## Shady Grove Sector Plan Minor Master Plan Amendment: Work Session No. 4: Mobility Analysis

Completed: 09/04/2020

### SUMMARY

Figure 1 – Single Point Urban Interchange

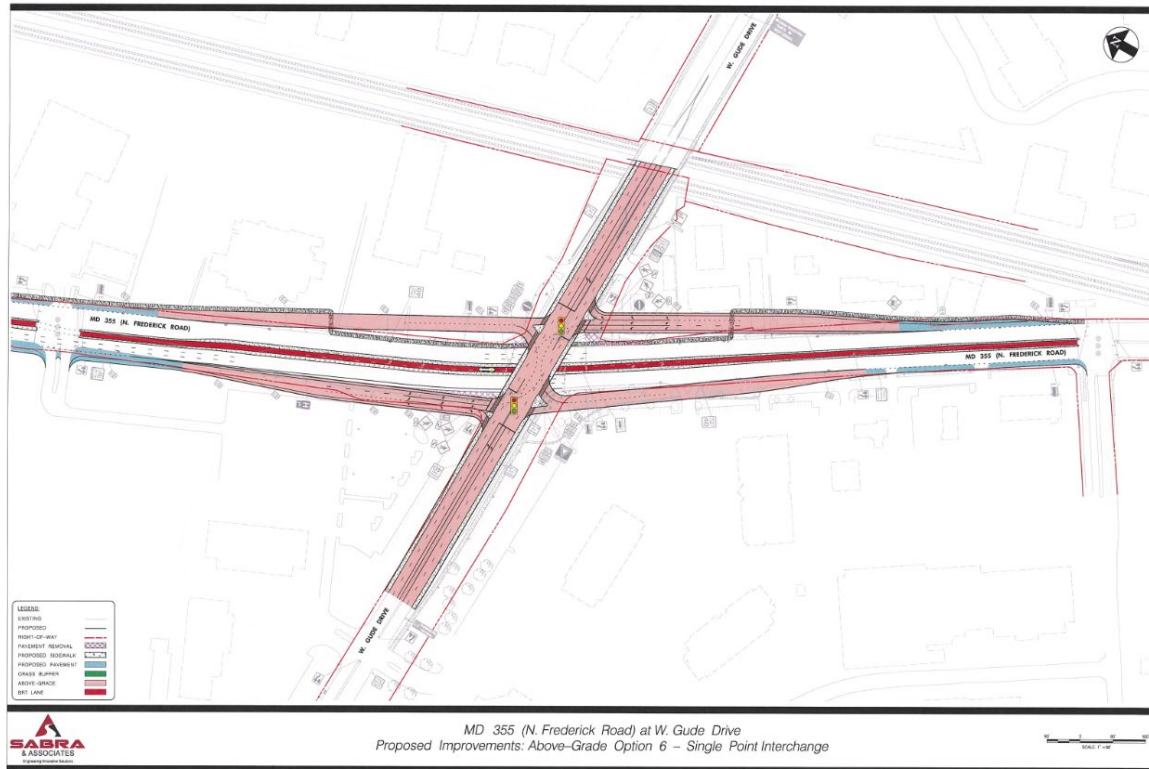
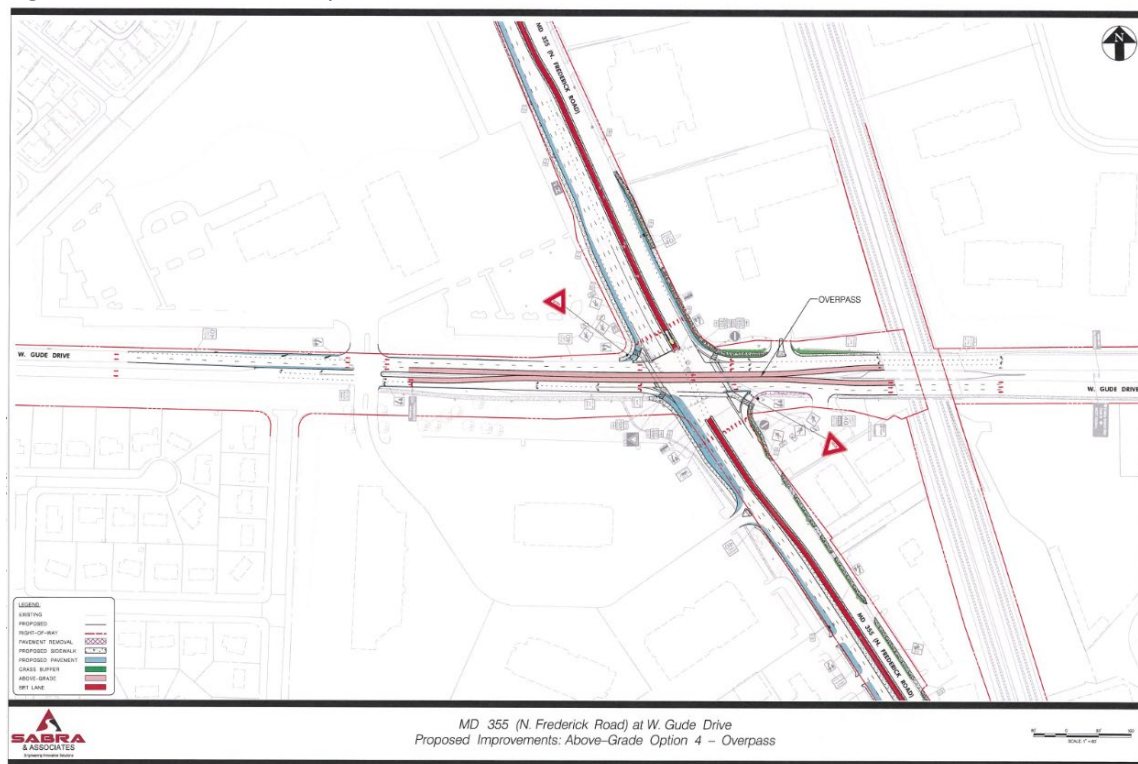
*MD 355 & Gude Drive Interchange:* Engineering consultant Sabra Wang & Associates worked with staff to assess the feasibility, costs, and benefits of a potential interchange at MD 355 and Gude Drive ([transportation appendix](#) (pg. 88)). This process documented significant property, access, and environmental impacts related to the implementation of either a single-point urban interchange (SPUI, shown in Figure 1) and Gude Drive Overpass (Figure 2), the two most viable interchange options. The Gude Drive Overpass option, which is projected to have a lower cost and fewer impacts than a single-point urban interchange, was modeled using a microsimulation tool. Microsimulation suggested that physical improvement of the intersection could result in modest benefits for some movements (particularly free flow movements on Gude Drive), but degradation to others. Upstream and downstream congestion along MD 355 prevents an isolated improvement from having any significant residual travel time benefit. In other words, queuing at intersections to the north and south of MD 355 and Gude Drive negates any supposed benefit of an interchange.

Both the City of Rockville and the Montgomery County Department of Transportation have commented that the State's Managed Lanes project may result in a new I-270 access point along Gude Drive, and that because of this, further evaluation of the interchange is warranted following a better understanding of the State's plans. If such an access point were to be implemented, it stands to reason that intersection volumes would increase, and that the heaviest movements would facilitate traffic from eastbound Gude Drive onto northbound MD 355 toward the Shady Grove Metrorail Station in the morning, and southbound from MD 355 back onto westbound Gude Drive in the evening. As an interchange would facilitate traffic more quickly to MD 355 in the morning, existing upstream congestion would likely be exacerbated, further reducing the benefit of any physical improvement. Department staff are working to obtain the necessary information from the State's Draft Environmental Impact Statement (DEIS) to better understand the order of magnitude for any potential volume increase associated with the Managed Lanes, but recommend the Board reaffirm its desire to remove the planned interchange from the *Master Plan of Highways and Transitways* as it is less desirable than other transit-oriented improvements.

1. MD 355 & Gude Drive Interchange: Staff's position and recommendation for the MD 355 and Gude Drive intersection is detailed on page 9 of this memorandum. Correspondence from the City of Rockville's Planning Chair states that increasing the delay threshold will "permit more development, while lessening the likelihood that a significant investment will take place to address the problem." Staff agrees that significant investment to improve person-throughput capacity in the Plan area is warranted but believes that—based on our detailed interchange feasibility, impact, and benefit analysis—an interchange is not the best significant investment for Shady Grove or the larger community. We appreciate Rockville's commendation of the Plan's transit-oriented recommendations, including support for the MD 355 BRT, the CCT, improved MARC Service, and the exploration of an infill WMATA Metrorail Station at Montgomery College.

One of our biggest concerns is the treatment of the intersection of E./W. Gude Drive and MD-355. The draft Plan recommends removing the previously planned grade-separated interchange as a staging requirement to permit new development and also recommends increasing the Highway Capacity Manual (HCM) standard of delay from 63 seconds to 80 seconds. This important intersection is very problematic, with significant congestion already experienced on a regular basis. The impact of both of these recommended changes would be to permit more development, while lessening the likelihood that a significant investment will take place to address the problem. We strongly encourage capacity improvements at that intersection while also maintaining the existing HCM congestion standard of 63 seconds of delay, in order to avoid further deterioration in the level of service at this location.

The Plan's consultants demonstrated that more minor geometric improvements could be made to MD 355 and Gude Drive, and that these improvements would bring the intersection's average delay below the 80 seconds/vehicle standard proposed by staff. The 80 seconds/vehicle proposal aligns with the Board's thinking related to its review of the Planning Board Draft of the *2020-2024 County Growth Policy*. The *2020-2024 County Growth Policy*, which has been transmitted to Council following the Board's approval, recommends a 100 seconds/vehicle average intersection delay threshold for intersections along planned Bus Rapid Transit Corridors, including MD 355. Planning staff anticipates the 80 seconds/vehicle threshold would be superseded by any more liberal policy approved by the County Council.

*A New Perspective on Significant Capital Improvements - Conclusions:* Staff recommends the Planning Board prioritize transit improvements rather than the previously planned interchanges, which should be removed from the *Master Plan of Highways and Transitways*. Maintaining the recommendations from

Figure 3 – Two-Lane Industrial Street Standard MC-2006.01

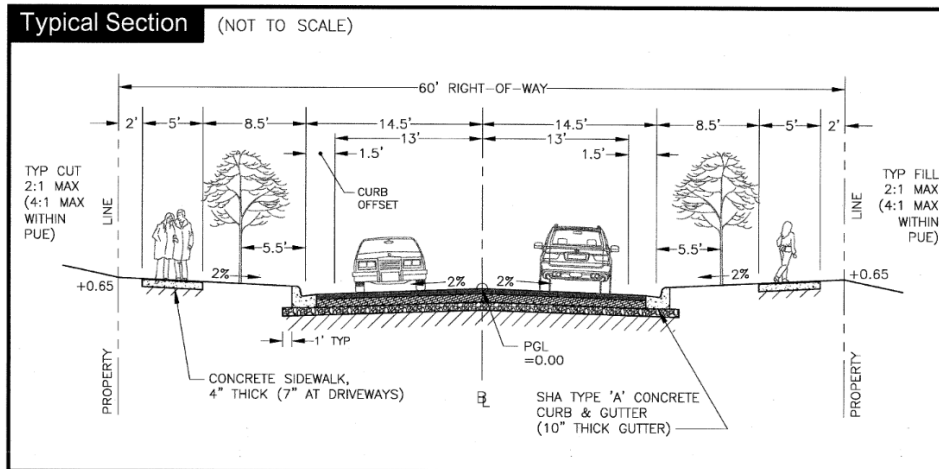
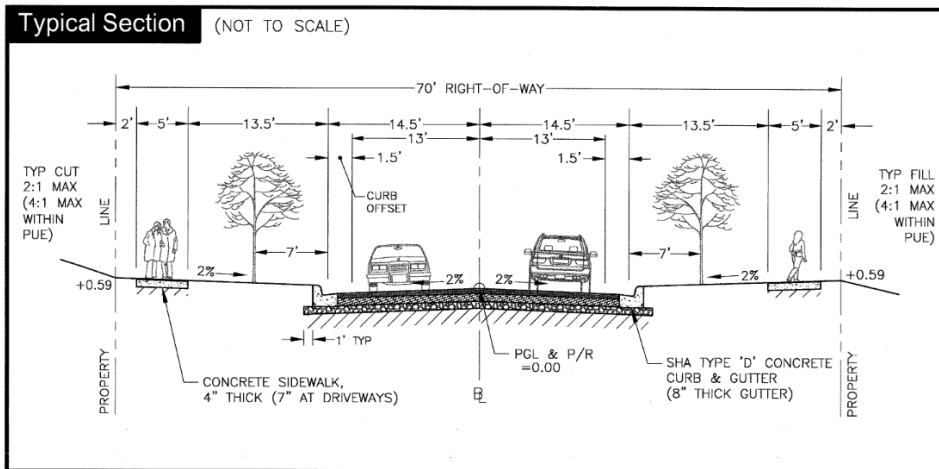
The Town contends that pedestrian safety along Oakmont Avenue has been largely ignored in the draft Plan Amendment. Staff agrees that the segment presents a very poor and unsafe pedestrian experience for users. The segment within the Plan area includes a significant number of sidewalk gaps. In some locations where sidewalks are present, they abut the roadway and lack separation from traffic. In locations where sidewalks abruptly terminate, crossings are not marked. Conditions are far from ideal.

Unaccountably, the safety of pedestrians using Oakmont Avenue has been virtually ignored in this Amendment. As light industrial use along Oakmont Avenue increased over the last decades bringing increased truck and vehicle traffic, and increased employment, little attention has been paid to pedestrian access to businesses or through traffic. The area has been re-classified moderate industrial. Though road improvements were made about 3 years ago, attention to pedestrian safety was given short shrift. It is irresponsible not to plan to rectify this immediately, let alone in the period of this master Plan.

Oakmont Avenue is currently classified as an 80-foot arterial by the *Master Plan of Highways and Transitways*. Today, the right-of-way width for the segment falling within the Plan area ranges between 25 feet and 80 feet. Generally, narrower sections prevail. The Plan did not recommend rezoning as the existing industrial uses are operating successfully. As there is no incentive to redevelop, it is unlikely that the recommended right-of-way width could be achieved in the life of the plan without property takings. A continuous sidewalk on one side of the street cannot be achieved today without property taking and utility line relocations, which would be an expensive capital project. Existing lane widths are approximately 13 feet. While two feet from each lane could be repurposed per the County's draft *Complete Streets Design Guidelines*, consistent with the Industrial Road typology, existing storm drain and swale channel infrastructure would need to be relocated and reconstructed. These constraints led staff to remove the 2018 Bicycle Master Plan bicycle facility recommendation from the roadway as it did not seem realistically achievable. A parallel connection to the Town of Washington Grove could provide an achievable alternative.

Staff also recommended the road be reclassified from an 80-foot arterial to a 60-foot industrial roadway to better align with existing conditions given the lack of prospect for redevelopment. Despite this change, staff notes that the 70-foot standard for a two-lane minor arterial (there is no existing two-lane 80-foot arterial standard) and the 60-foot industrial roadway standard are largely consistent. The 70-foot standard increases the adequate 8.5-foot separation between the sidewalk and the roadway to be 13.5 feet (see Figures 3 and 4 below). Other than buffering, the widths for each element of the two different standards are the same, and both include sidewalk facilities.

Unfortunately, without a mechanism to obtain right-of-way or relocate existing structures and utilities, discussions regarding classification are largely academic. As such, staff recommends the Board consider the addition of the following recommendation: *Encourage coordination between existing property owners, the County, and the Town of Washington Grove to improve pedestrian safety along Oakmont Avenue, including the provision of a continuous sidewalk on at least one side of the roadway.*
